ARCHITECTURAL REVIEW COMMITTEE MEMORANDUM

DATE: JULY 5, 2022 UNFINISHED BUSINESS

SUBJECT: ONE LAS PALMAS, LLC FOR A MAJOR ARCHITECTURAL APPLICATION FOR THE REVIEW OF FOUR (4) SINGLE-FAMILY HOUSE TYPES ON ELEVEN (11) HILLSIDE LOTS AND AN ADMINISTRATIVE MINOR MODIFICATION FOR A FRONT YARD SETBACK REDUCTION FOR THREE LOTS AND INCREASE IN BUILDING HEIGHT FOR FOUR (4) HOUSE ELEVATIONS LOCATED AT LAS PALMAS ESTATES DRIVE, ZONE R-1-B, SECTION 1. (CASE 3.4194 MAJ & 7.1648 AMM)(GM)

- **Plan 1 B**

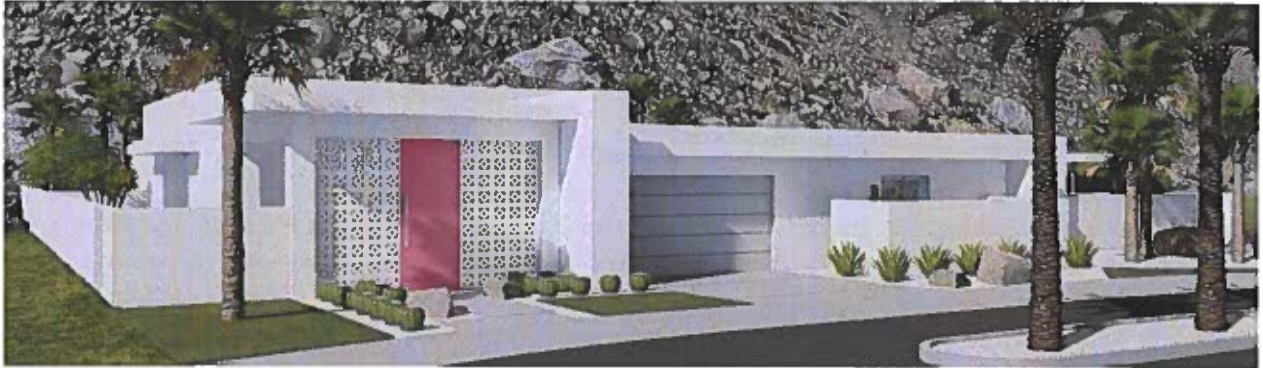
In reviewing the side and rear house elevations, staff suggested that the applicant add control joints or other elements to break up Plans 1A, 1B, 2A, 2B that have the sixteen (16') foot tall wall at the side yard setback. In addition, solar control elements such as longer eaves, or eyebrows should be used on the west facing exposed glazing. Staff realizes that the mountain will cast a shadow over these lots, however in the summertime these buildings will be in bright sunlight.
